DESIGN AND CONSTRUCTION MANUAL DESIGN MODIFICATION REQUEST

PROJECT NAME: Streets of West Pryor - Lot 10

Re: The Streets of West Pryor Pavement Sections
Lee's Summit, Missouri
CFS # 19-1066

**RECOMMENDED
SECTION**

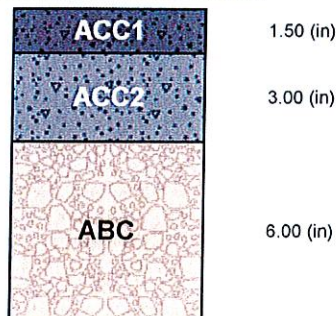
COMMENTS Minimum lift thickness for APWA Type 1 asphalt is 3 inches
Adjust pavement section by either a) Change base to APWA type 2
or b) 3" APWA Type 3 with revised pavement design analysis
